Euro Jeans Ltd

Chowdhury Bari, Vogra ,Gazipur
(23.9789348N,90.3802407E)

14th May 2014

Observations

Shed 1 – Distorted end plates / inadequate bearing of end plates

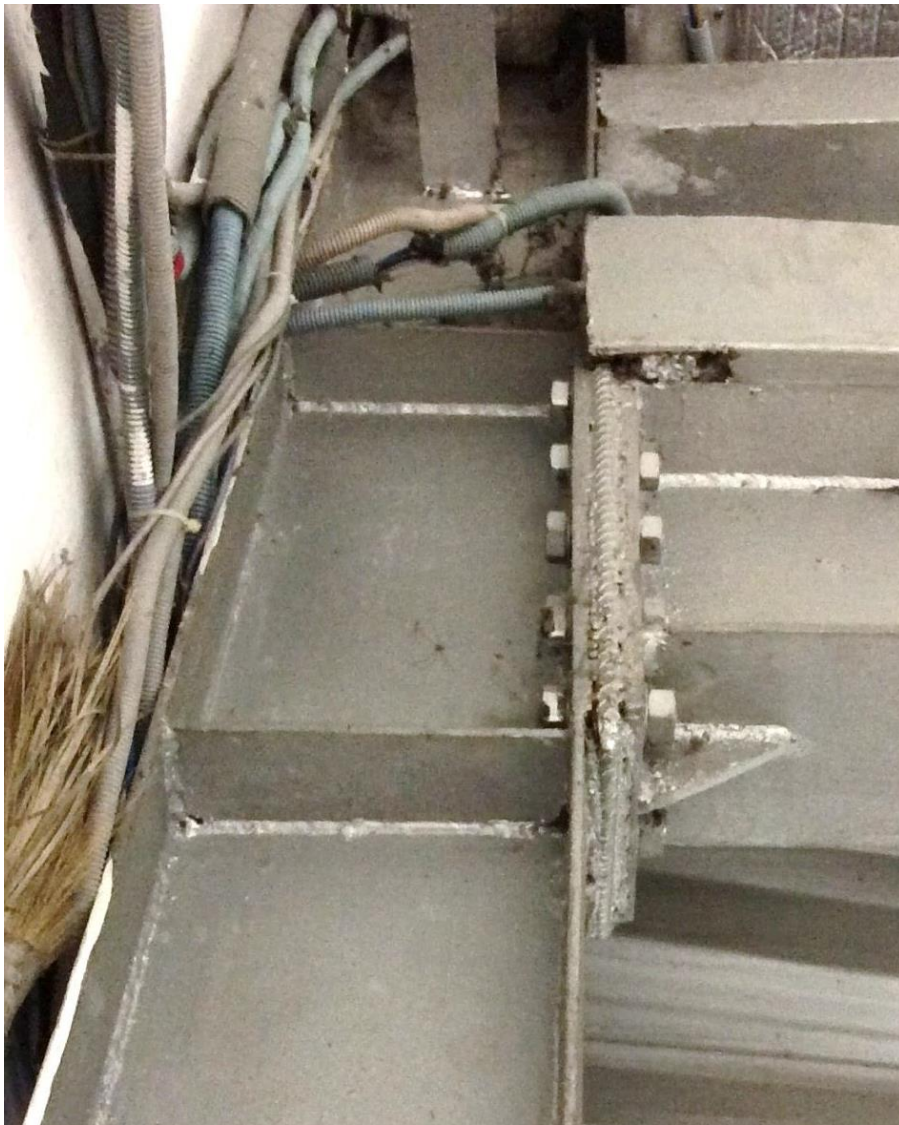
Defects and poor workmanship was observed to a large number of steel connections in Sheds 1 and 2, including distortion and buckling of the connection plates, inadequate bearing / opening up of end plates, inadequate welds, bolt omissions and inadequate replacements, severe rusting and pitting. The issues are likely a cause of overstressing, excessive movement due to instabilities or substandard quality of fabrication / erection. Detailed Engineering Assessment required.

Shed 1 – Welded connection instead of bolted connection

Shed 1 – Distorted end plates / inadequate bearing of end plates

Item No.	Observation	Recommended Action Plan	Recommended Timeline
1	Defects and poor workmanship to the steelwork connections in Sheds 1 and 2	Building Engineer to review all connection details in Sheds 1 and 2 with immediate effect as part of Detailed Engineering Assessment, refer to attached scope.	Immediate - Now
2	Defects and poor workmanship to the steelwork connections in Sheds 1 and 2	Building Engineer to prepare schedule of remedial works, as required.	Immediate - Now
3	Defects and poor workmanship to the steelwork connections in Sheds 1 and 2	Detailed Engineering Assessment to be completed.	6-weeks
4	Defects and poor workmanship to the steelwork connections in Sheds 1 and 2	Building Engineer to implement any actions / supervise any remedial works as identified following the review.	6-months
5	Concerns over support detail to gable-end rafter at 1st floor level of Shed 2	Building Engineer to review stability of said rafter, as part of Detailed Engineering Assessment, and to prepare schedule of remedial works as required.	Immediate - Now

Shed 1 – Missing bolts

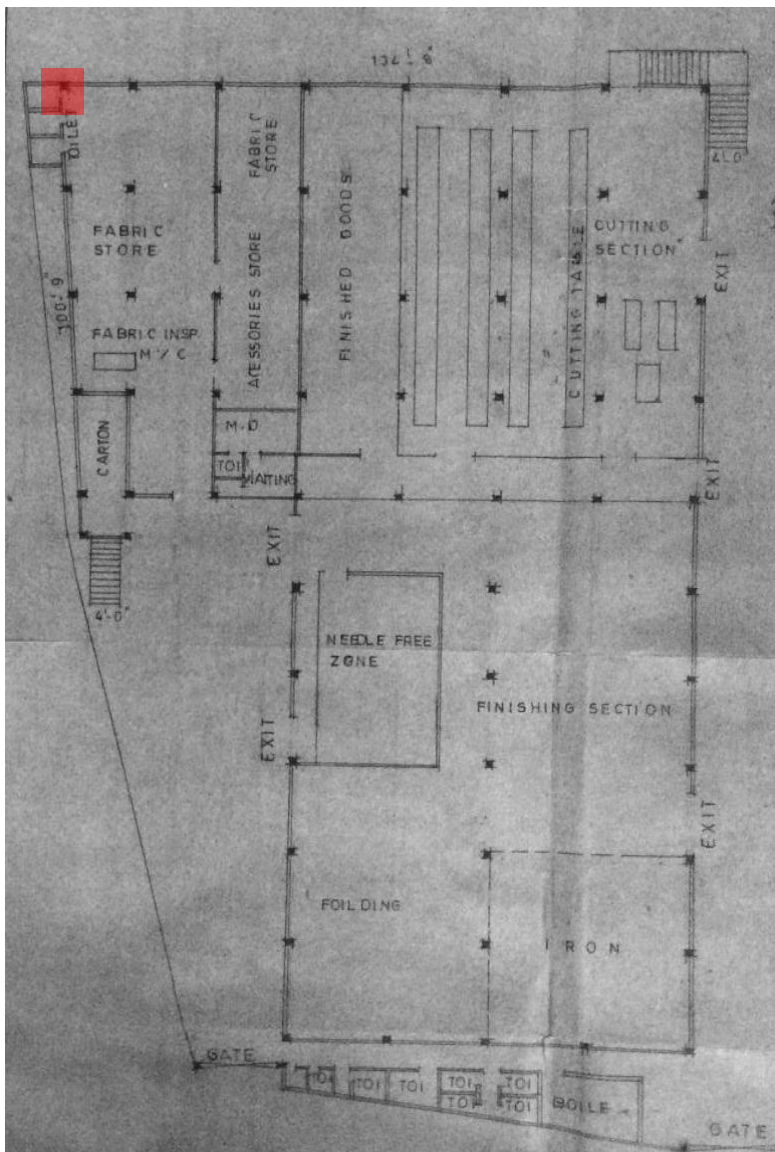
Shed 1 – A large number of connections were observed to have been altered – Rebar appears to have been welded to end plates where there is inadequate bearing.

Shed 1 – In many cases where rebar appears to have been welded to end plates as a remedial solution to inadequate bearing, the detail is poorly executed.

Shed 1 – Inadequate bolt replacements – it appears as though a smaller diameter bolt has been used

Shed 2 – Ground Floor Plan

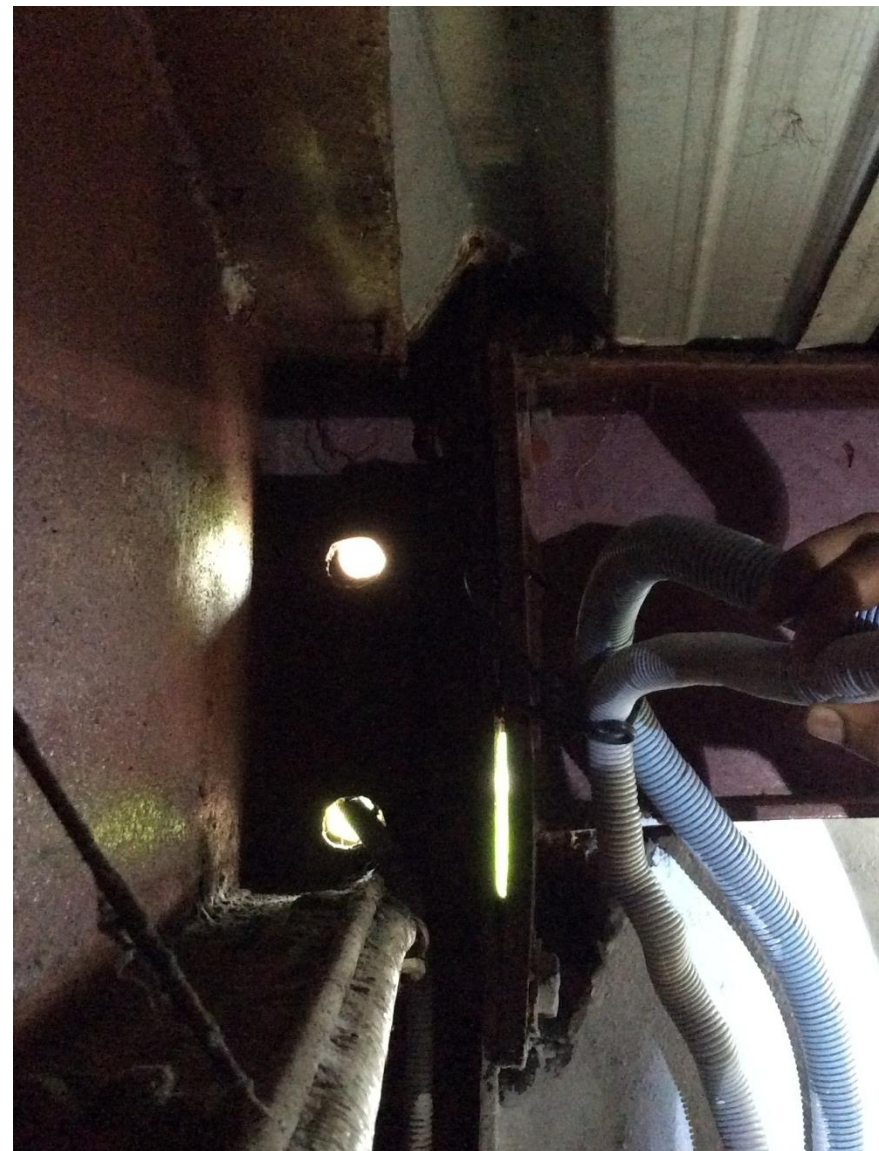
Location of buckled end plate

Shed 2 – Buckled end-plate to First Floor edge beam. The plate appears to have buckled either from overstressing and / or inadequate connection

Shed 2 – Ground Floor Plan

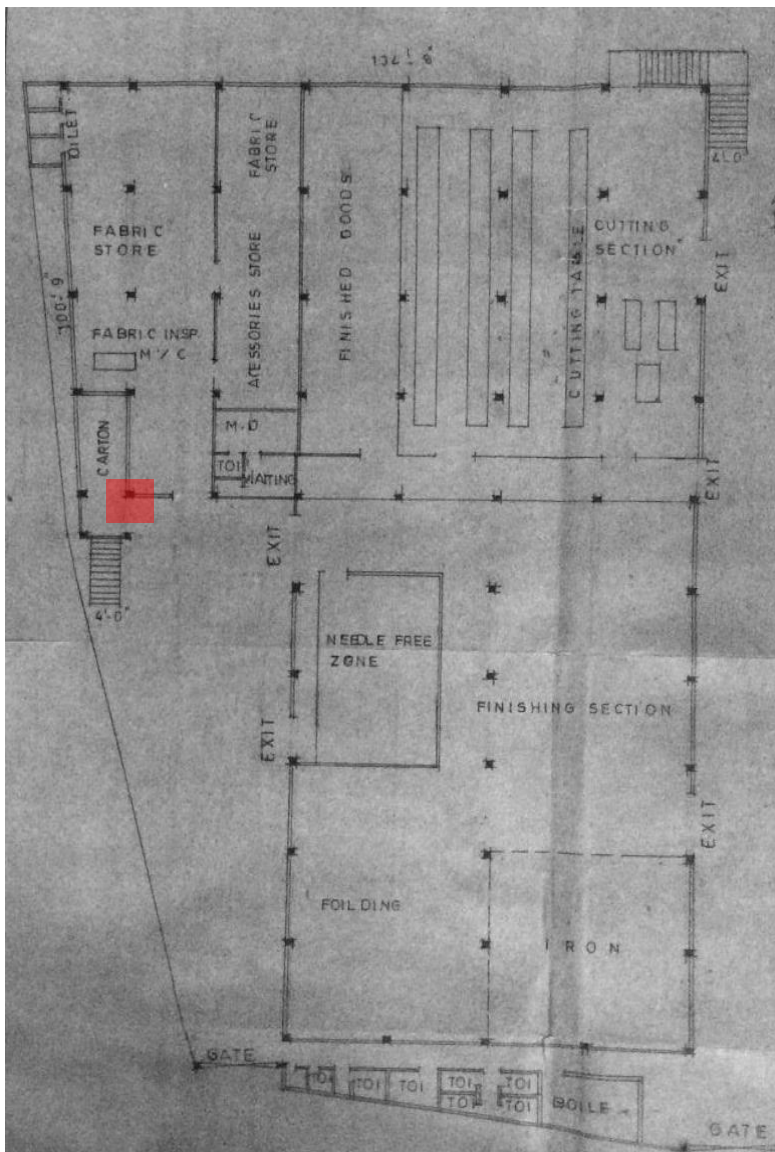
Corroded / pitted steel column

Shed 2 – Column appears to have been painted without adequate remedial work to treat corrosion.

Shed 2 – Missing bolts to portal frame rafter

Shed 2 – Distorted end plates / inadequate bearing of end plates to central rafter support

Shed 2 – 1st Floor Plan

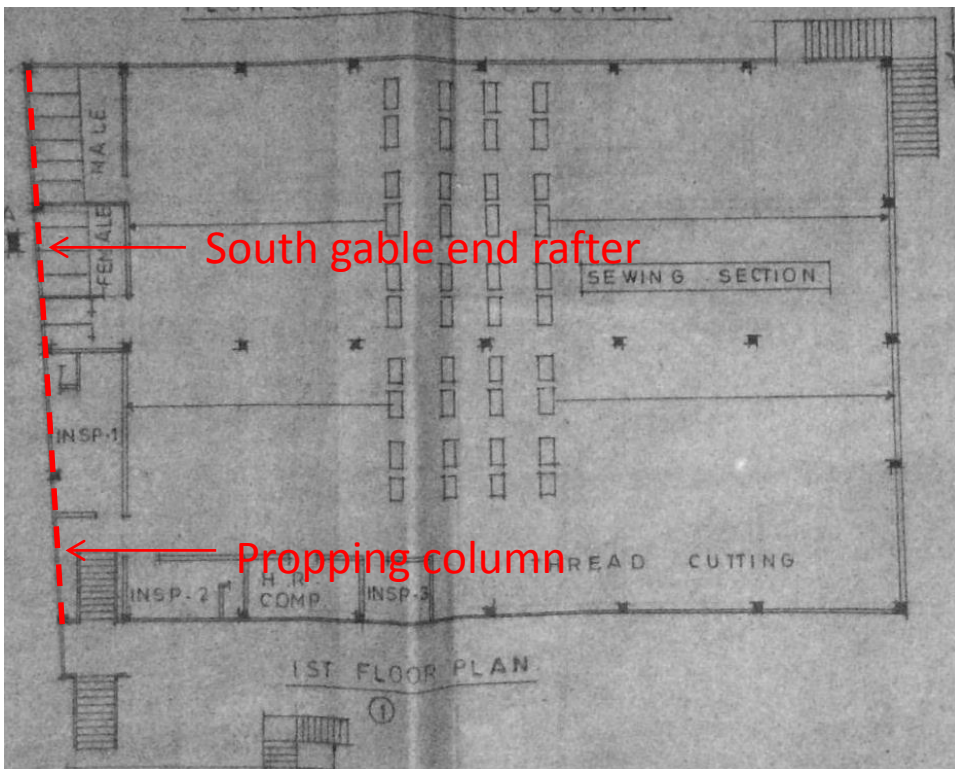
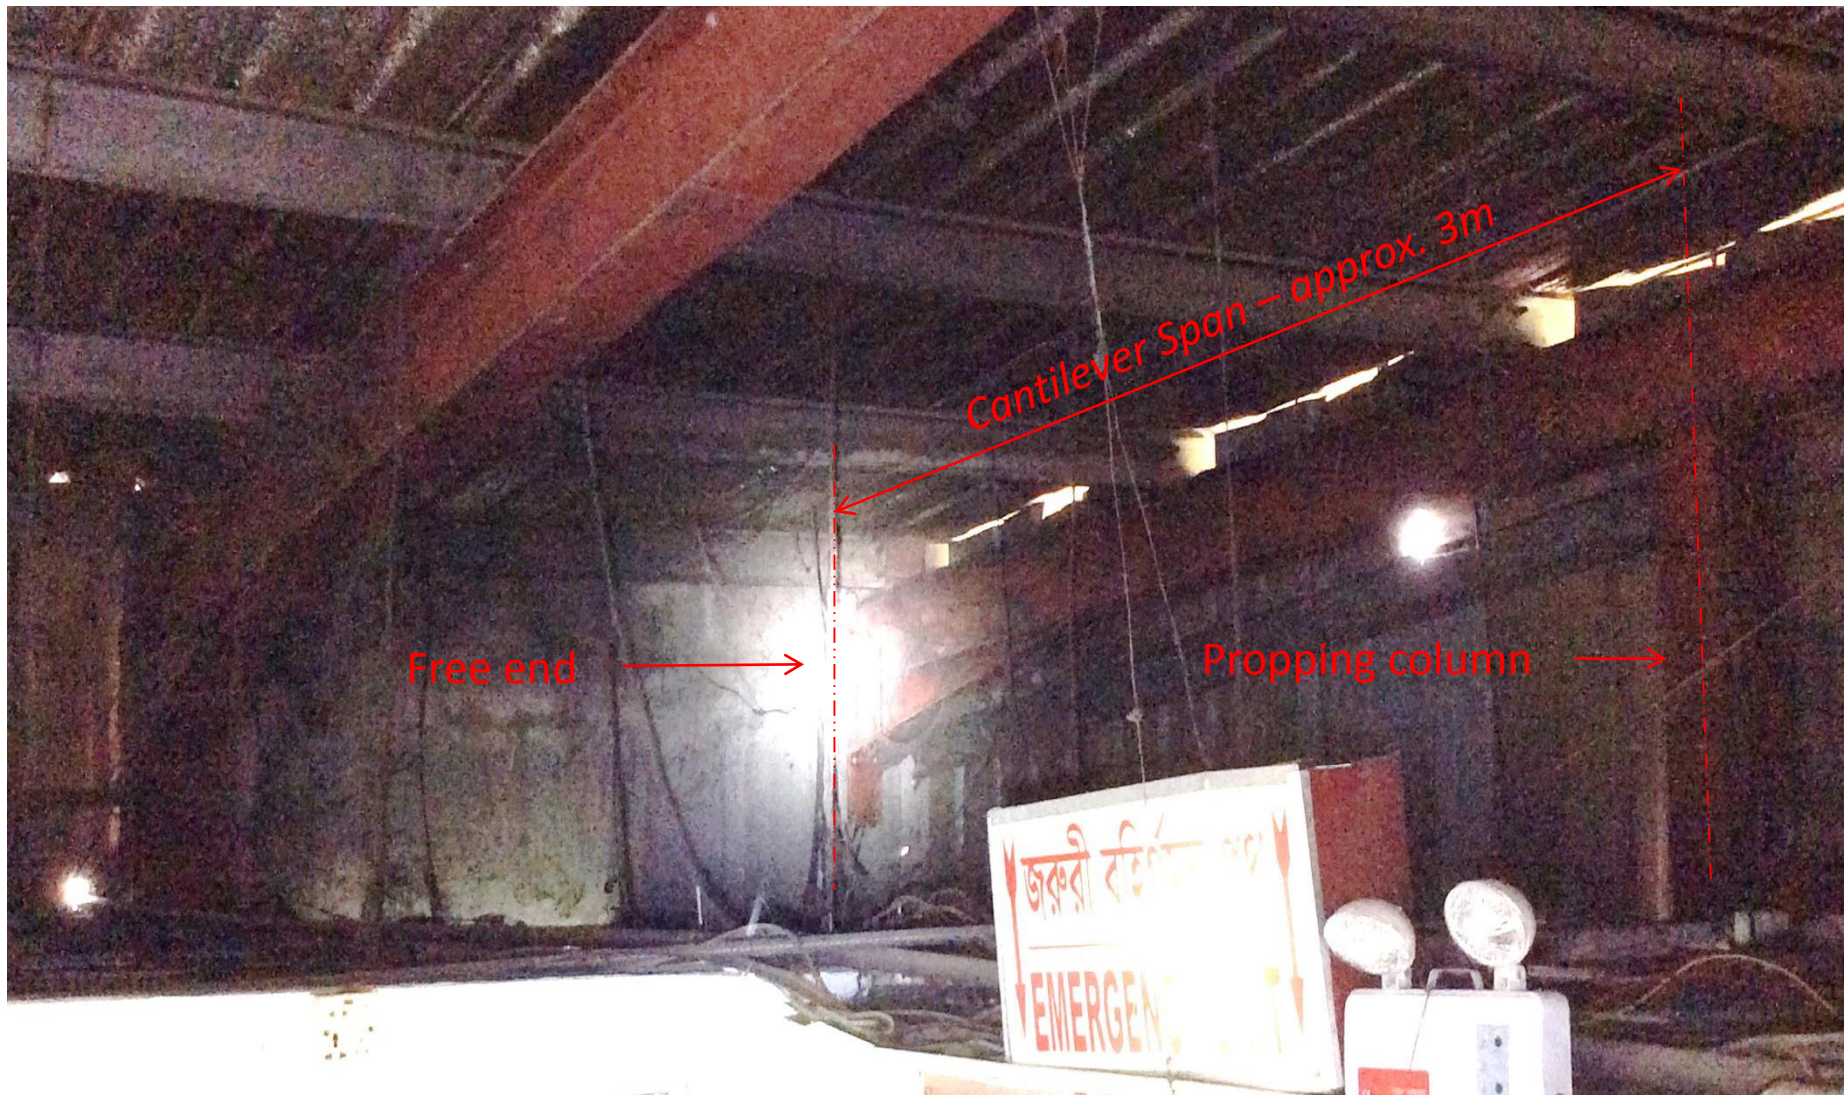
Concerns over support detail to gable-end rafter at 1st floor level of Shed 2

There are concerns over the structural adequacy of the rafter to the south gable end of Shed 2. The detail of the portal frame to the South-East corner is atypical: the rafter butts up against the water tank wall instead of a column, and there is no connection to the water tank wall. The rafter is instead propped up by a cantilevering steel column and cantilevers approximately 3m beyond the prop to where it meets the water tank wall. The connection detail between the rafter and the prop is unclear, although the moment capacity of the portal frame appears to have been lost. Detailed Engineering Assessment required.

Propping column

Unconnected end of rafter to South-East corner; rafter propped by a cantilevering steel column

6	Concerns over support detail to gable-end rafter at 1st floor level of Shed 2	Detailed Engineering Assessment to be completed.	6-weeks
7	Concerns over support detail to gable-end rafter at 1st floor level of Shed 2	Building Engineer to implement any actions / supervise any remedial works as identified following the review.	6-weeks

Shed 2 – Ground Floor Plan

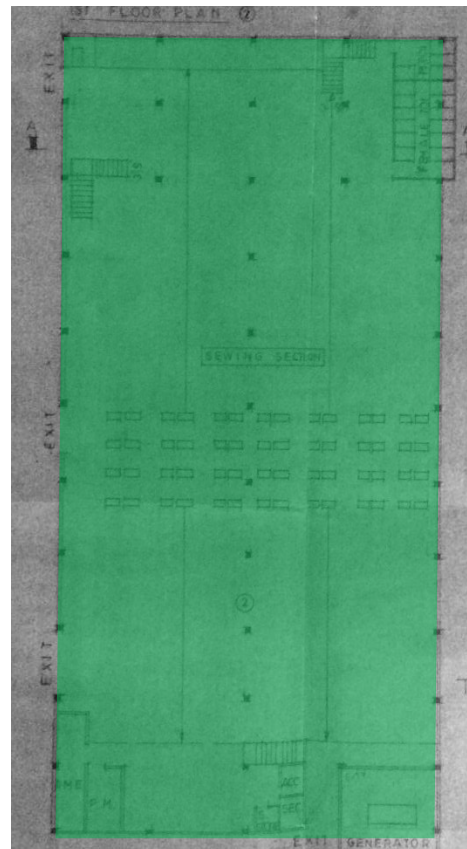
Horizontal and vertical diagonal cable bracing is missing from the two-storey structure of Shed 2, vertical bracing is missing from the single-storey structure of Shed 2, and while bracing is provided to Shed 1, it is loose and therefore ineffective. There appears to be a misunderstanding as to the requirements for bracing in providing support for wind load. Building Engineer to review requirements for bracing to Sheds 1 and 2, and supervise installation and tightening of bracing as necessary.

Shed 1 – Horizontal and vertical cable bracing provided, but loose and ineffective.

Shed 2 – Two-storey structure – Horizontal and vertical cable bracing missing.

Shed 2 – Single -storey structure – Vertical cable bracing missing. Horizontal bracing appears loose.

Shed 2 – Two-storey structure – Horizontal and vertical bracing missing

Shed 2 – Single-storey structure – Horizontal bracing missing

Item No.	Observation	Recommended Action Plan	Recommended Timeline
8	Lack of / inadequate stability members in Sheds 1 and 2	Building Engineer to provide necessary vertical and horizontal bracing to Shed 2 and to tighten bracing to Shed 1.	6-weeks
9	Unsupported masonry walls to Sheds 1 and 2	Building Engineer to review lateral stability of masonry walls and to prepare a schedule of remedial / strengthening works, as required.	6-weeks
10	Unsupported masonry walls to Sheds 1 and 2	Building Engineer to implement any actions / supervise any remedial works as identified following the review.	6-months
11	Concerns over stability of air vent support beams to roof of Shed 1	Building Engineer to carry out review of connection between air vent support beams and the rafters to which they are connected, and to prepare a schedule of remedial / strengthening works, as required.	6-weeks
12	Concerns over stability of air vent support beams to roof of Shed 1	Building Engineer to implement any actions / supervise any remedial works as identified following the review.	6-months

Masonry wall to Shed 2

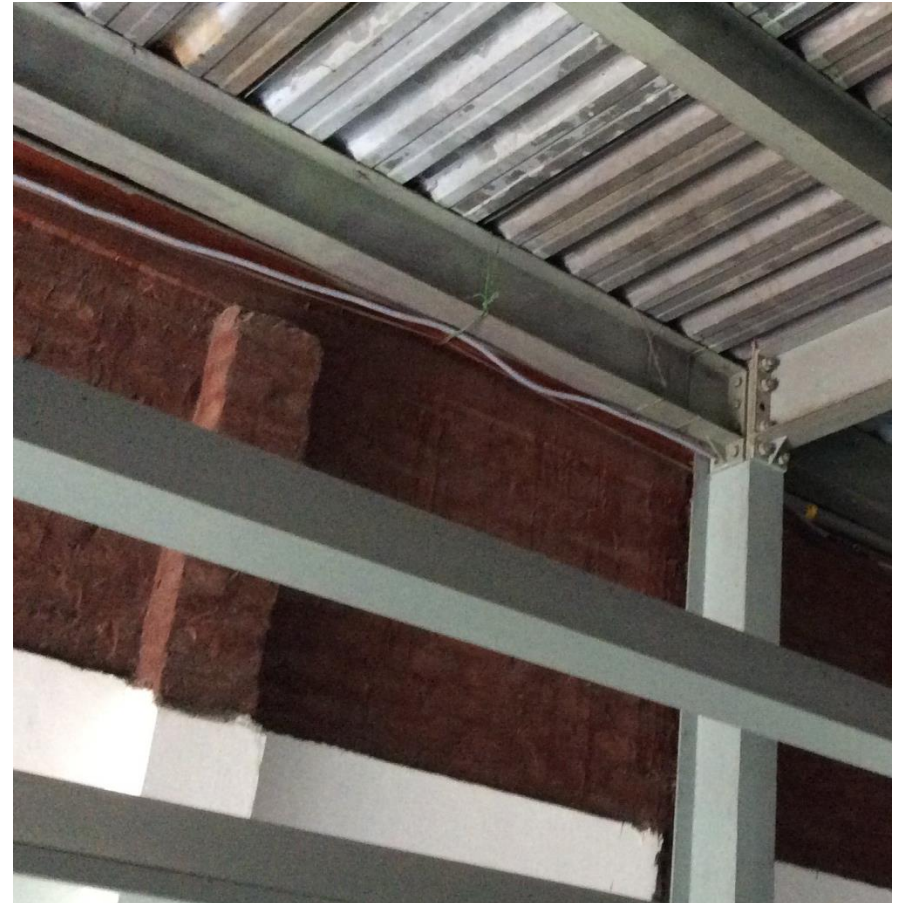
There are concerns over the lateral stability of the masonry walls to sheds 1 and 2. The walls are approximately 4m high and have brick piers, as opposed to RC columns, which appear to be cantilevering from Ground Floor level. There is no connection between the masonry walls and the portal frame structures.

Brick piers and no connection between masonry walls and portal frame columns

Air vents viewed from Shed 1 floor

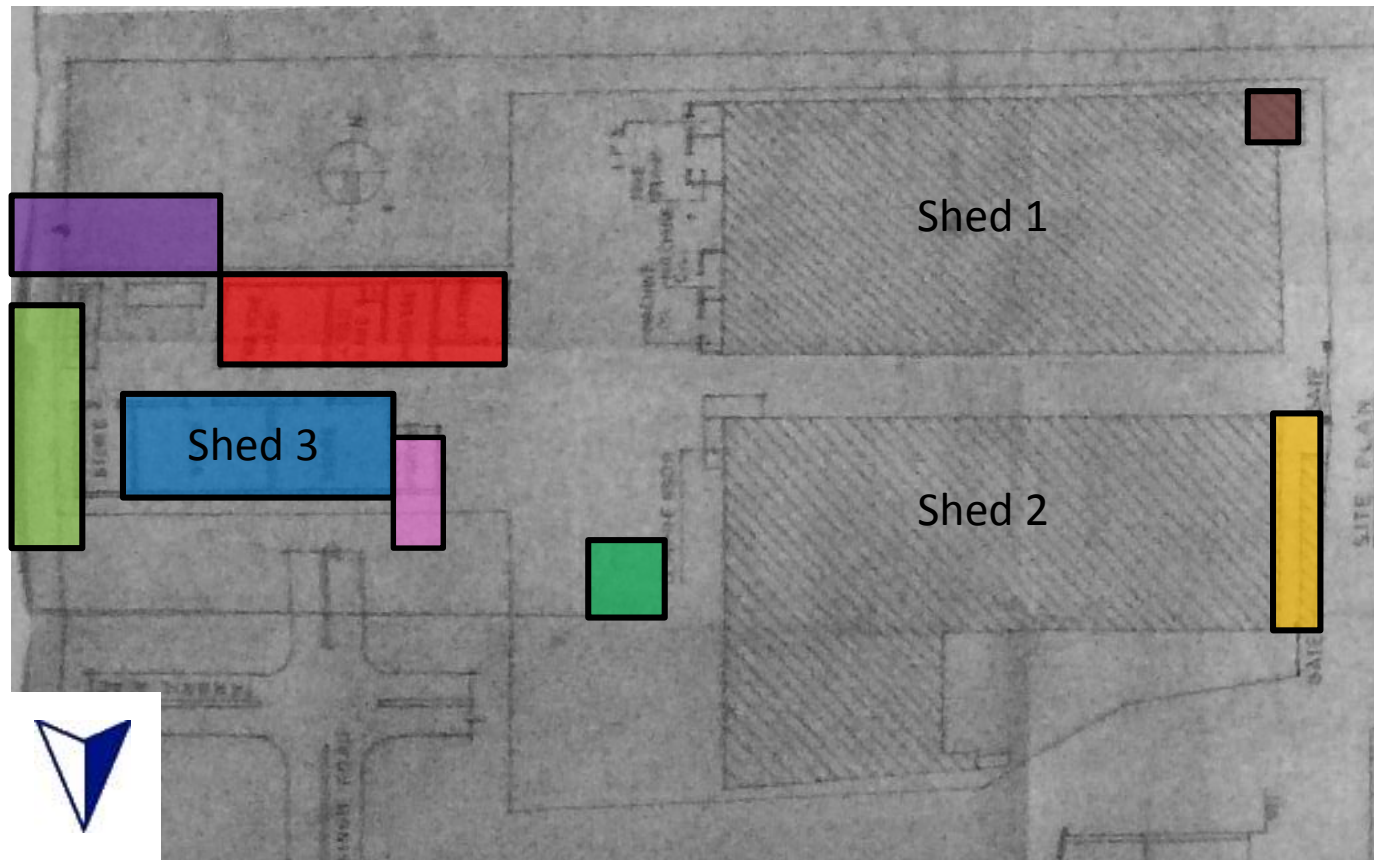
There are concerns over the stability of the steel beams erected above the portal frame rafters of Shed 1 to provide support to the air vents. The arrangement appears unstable.

Connection detail unclear – single bracing member only
